# Work Order ID 97859

Item Name: Crosstube Assembly, Mid Aft

DRAWING NO. D206-667-247	TITLE CROSSTUBE ASS'Y (206L MID AFT)	REV. A	<b>DART AEROSPACE LTD ENGINEERING ORDER</b>		D.E.O. NO. D206-667-247-A-1	SHEET NO. SHEET 1 OF 1	SCALE NTS
DRAWN 92	CHECKED ASS	MFG. APPR. KB	APPROVED JMD		DE APPR. H		
DATE 11.07.15	DATE 11.07.20	DATE 11.07.21	DATE 11/07/21		DATE 11.7.21

**PURPOSE:**

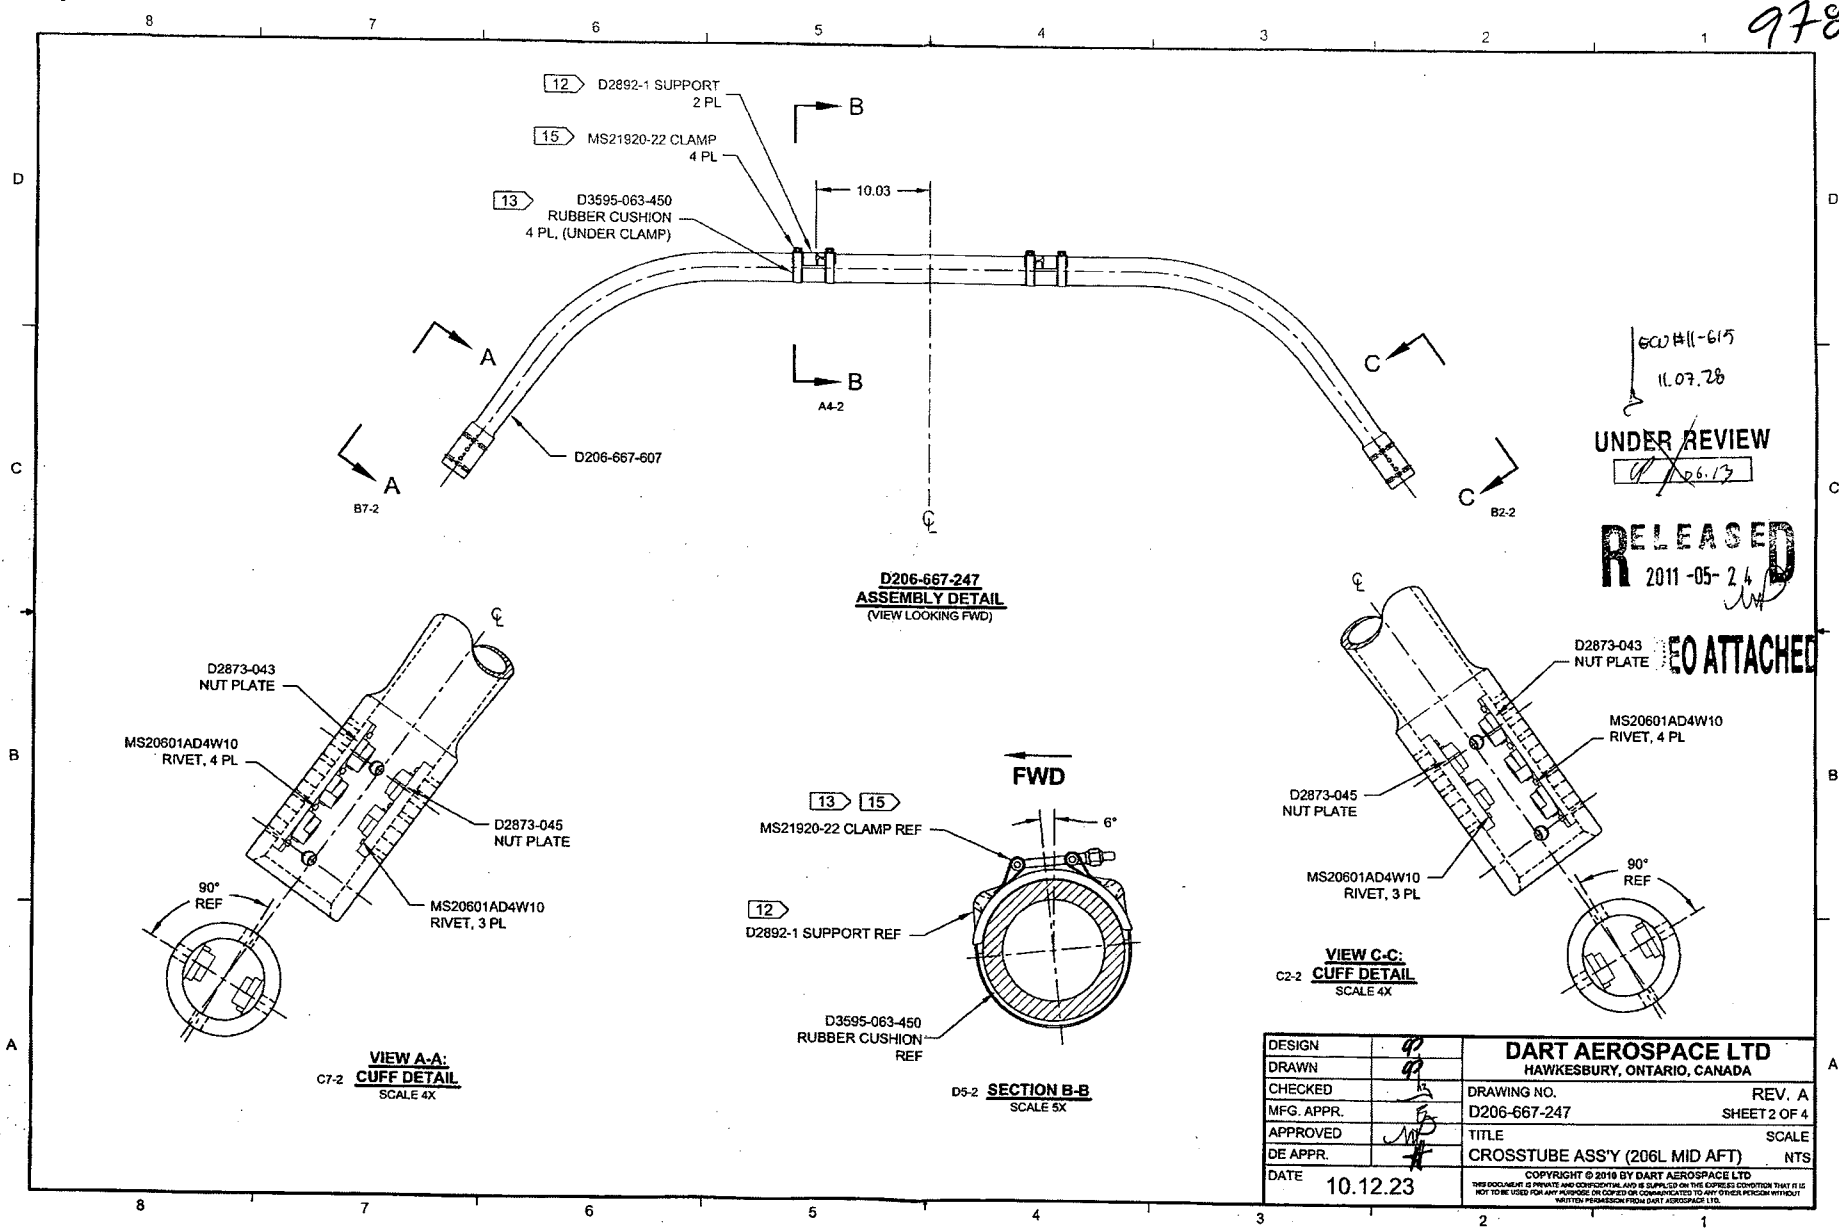
REPLACE MAGNOBOND WITH PROSEAL.

Item	Qty -247	Part Number	Description
9	A/R	PROSEAL 890 B-2	SEALANT, AMS-S-8802 CLASS B-2

9	A/R	MAGNOBOND 6398	ROCKWELL SPECIFICATION RBO-120-023 ADHESIVE (TEXTRON/BELL SPEC. 299-947-100, TYPE II, CLASS 2 ADHESIVE)
---	-----	----------------	---

NOTE 12 & 15, SHEET 1 IS AMENDED AS FOLLOWS:

- 12) INSTALL D2892-1 SUPPORT USING 0.03" TO 0.06" THICK LAYER OF MAGNOBOND 6398 PER QSI 015. LET CURE FOR 12 HOURS AFTER INSTALLATION AND PRIOR TO PACKAGING.
- 15) TORQUE CLAMPS 80 TO 100 IN.-LB. ENSURE AT LEAST 1.5 THREADS SHOWING IN SAFETY AND THAT NUT HAS NOT BOTTOMED-OUT AFTER TORQUING.

- 12) TO INSTALL D2892-1 SUPPORT: ABRASE MATING SURFACE OF SUPPORT AND CROSSTUBE WITH 180-GRIT SANDPAPER AND REMOVE RESIDUE WITH MEK (OR EQUIVALENT). APPLY A 0.04" TO 0.07" THICK LAYER OF PROSEAL 890 CLASS B-2 (OR AMS-S-8802 CLASS B-2) SEALANT TO MATING SURFACE OF SUPPORT.
- 15) TORQUE CLAMPS 80 TO 100 IN.-LB. ENSURE AT LEAST 1.5 THREADS SHOWING IN SAFETY AND THAT NUT HAS NOT BOTTOMED-OUT AFTER TORQUING. **PRIOR TO PACKAGING, RE-CHECK TORQUE ON CLAMPS AFTER PROSEAL 890 SEALANT HAS CURED FOR 72 HOURS.**
